LR-N02-0039  
LCR H02-04

**REQUEST FOR CHANGE TO TECHNICAL SPECIFICATIONS  
EXTENDED USE OF PRESSURE – TEMPERATURE LIMIT CURVES  
HOPE CREEK GENERATING STATION  
FACILITY OPERATING LICENSE NPF-57  
DOCKET NO. 50-354**

**EVALUATION OF REVISIONS TO THE TECHNICAL SPECIFICATIONS  
FOR EXTENDED USE OF PRESSURE-TEMPERATURE LIMIT CURVES**

**Figure 3.4.6.1-1  
Hydrostatic Pressure and Leak Tests Pressure/Temperature Limits - Curve A**

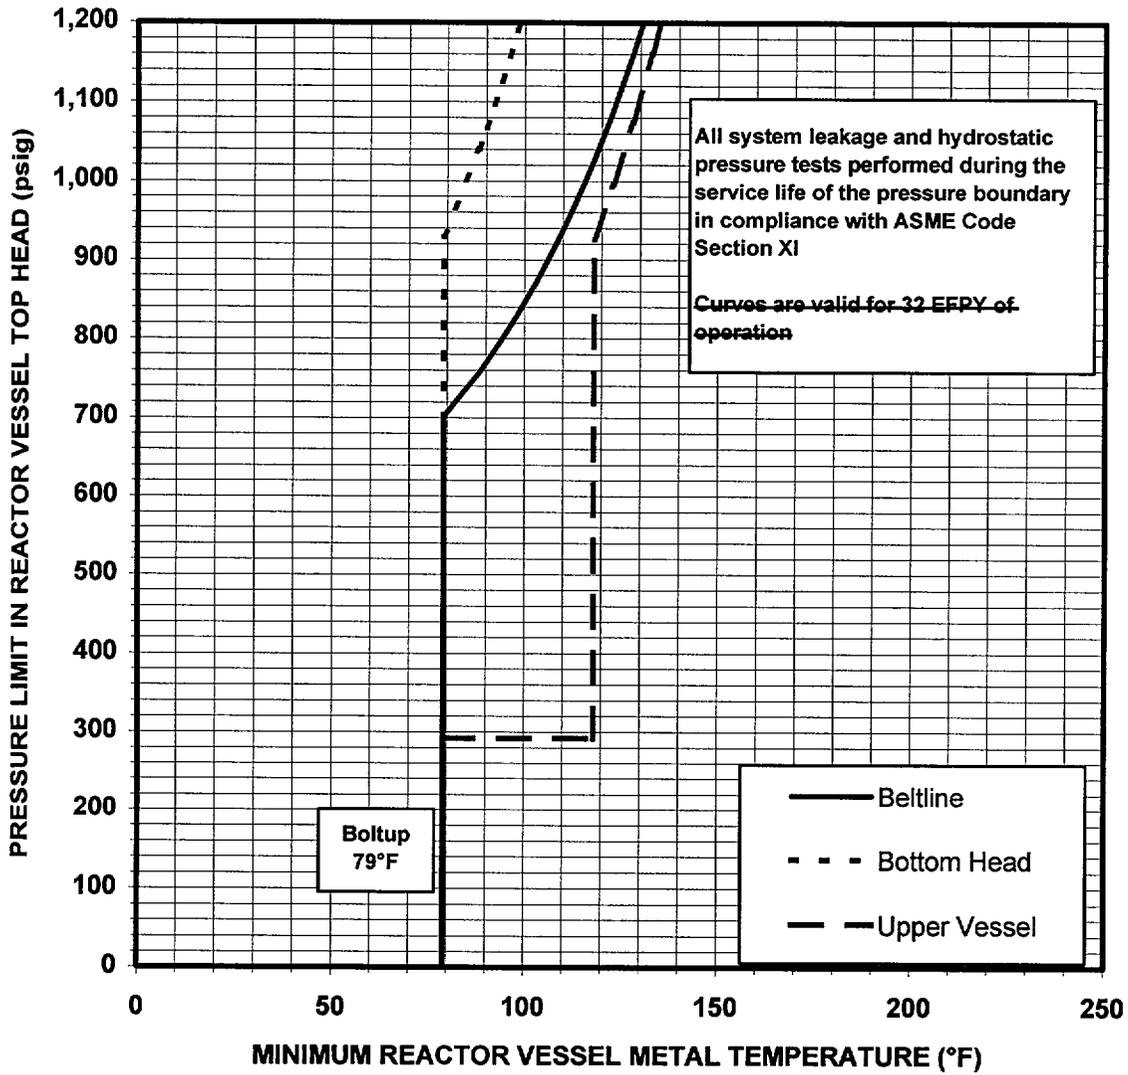
The proposed changes to the Technical Specifications would revise the footnote on Figure 3.4.6.1-1, "Hydrostatic Pressure and Leak Tests Pressure/Temperature Limits- Curve A," Figure 3.4.6.1-2, "Non-Nuclear and Cooldown Pressure/Temperature Limits – Curve B," and Figure 3.4.6.1-3, "Core Critical Heatup and Cooldown Pressure/Temperature Limits – Curve C." The current footnote states, "This figure is valid through Cycle 11 Operation in accordance with NRC Safety Evaluation supporting Amendment No. 131." The revised footnote will read, "This figure is valid through Cycle 12 Operation in accordance with NRC Safety Evaluation supporting Amendment No. \_\_\_\_."

For consistency purposes, the note on figures 3.4.6.1-1, 3.4.6.1-2 and 3.4.6.1-3 which states that the, "Curves are valid for 32 EFPY of operation" is being deleted.

For consistency purposes, the note on figures 3.4.6.1-1, 3.4.6.1-2 and 3.4.6.1-3 which states that the, "Curves are valid for 32 EFPY of operation" is being deleted. Removal of this note will eliminate any confusion associated with the note that will state that the curves are only valid to the end of cycle 12.

Note: This figure is valid through Cycle 44-12 Operation in accordance with NRC Safety Evaluation Report supporting Amendment No. \_\_\_\_\_

Figure 3.4.6.1-2

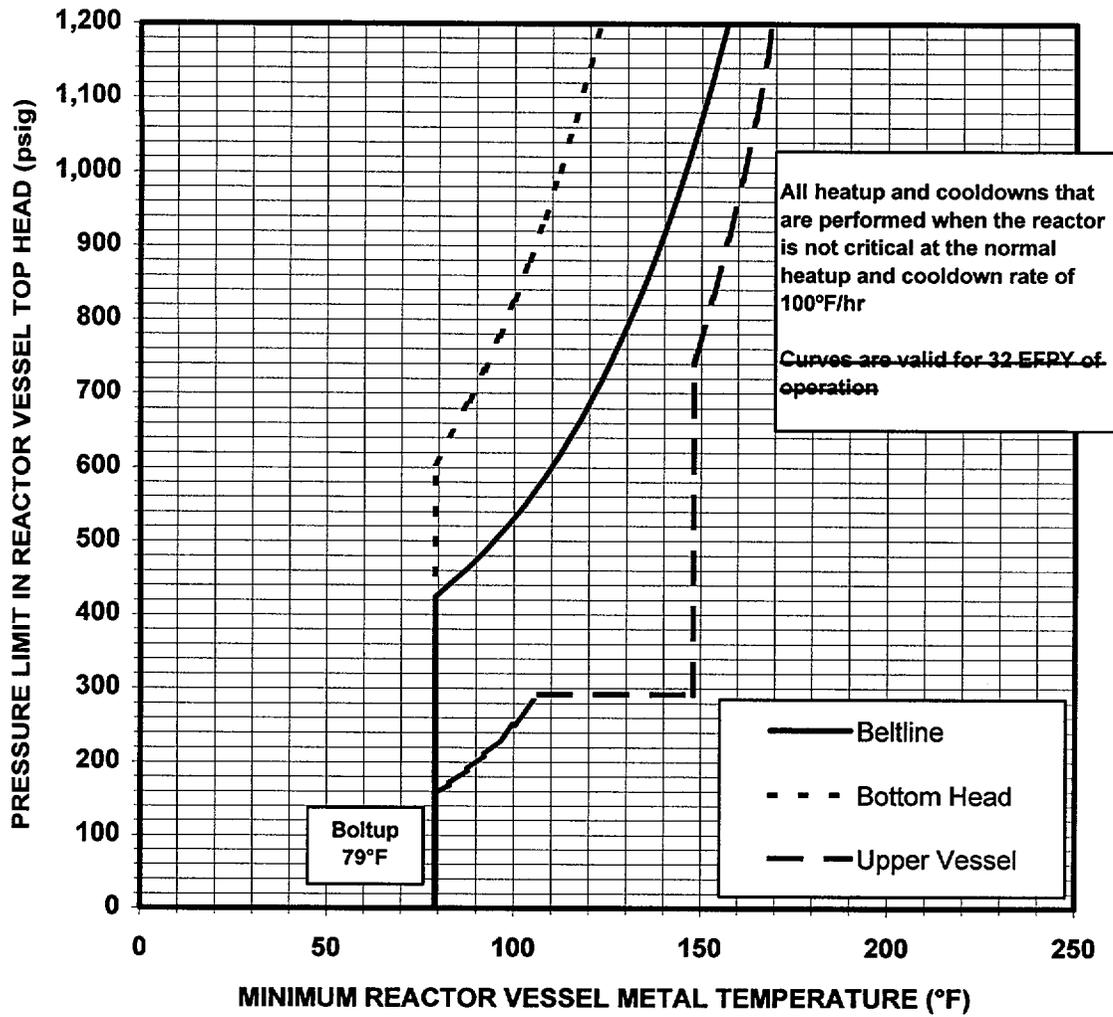
Note: This figure is valid through Cycle 44 12 Operation with NRC Safety Evaluation Report supporting Amendment No. \_\_\_\_\_

Figure 3.4.6.1-3

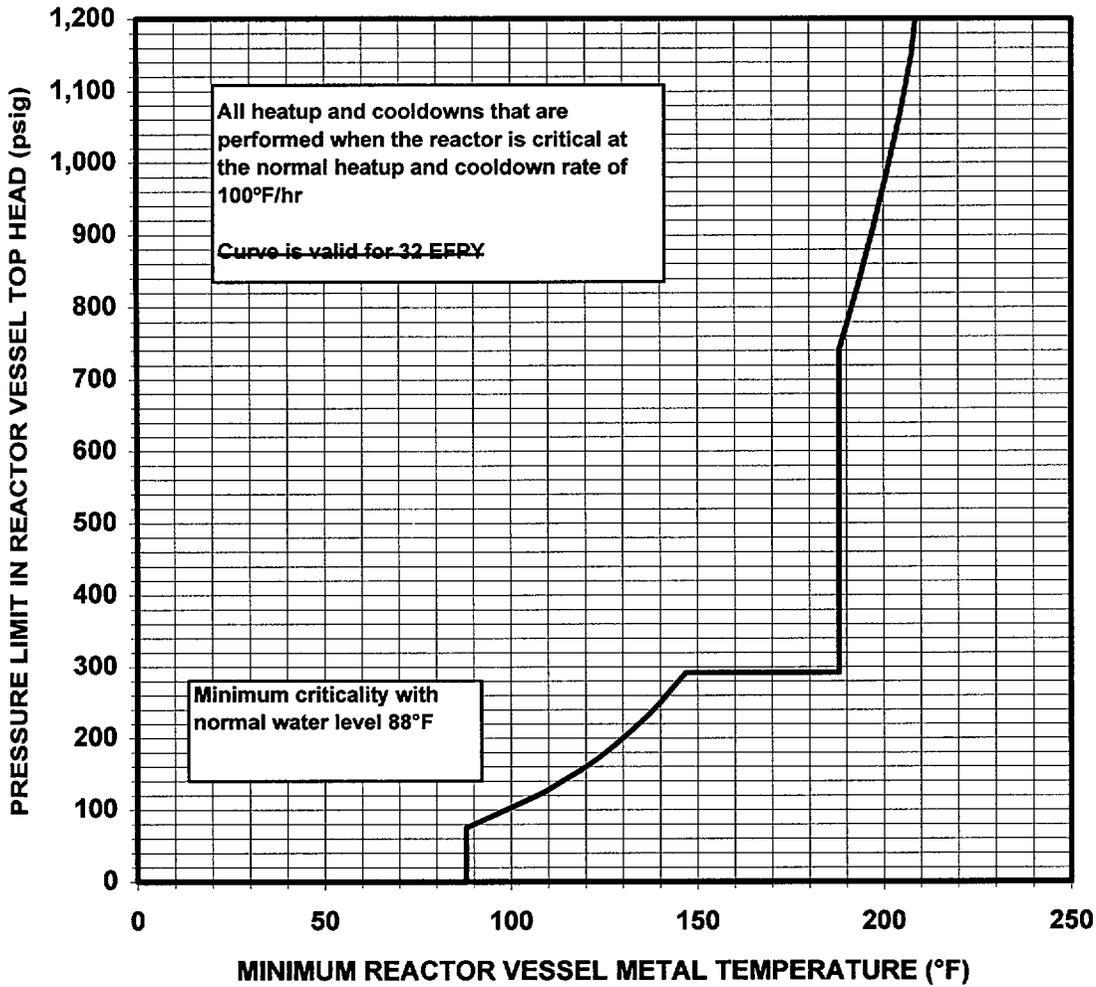
Note: This figure is valid through Cycle 44 12 Operation in accordance with NRC Safety Evaluation Report supporting Amendment No. \_\_\_\_\_
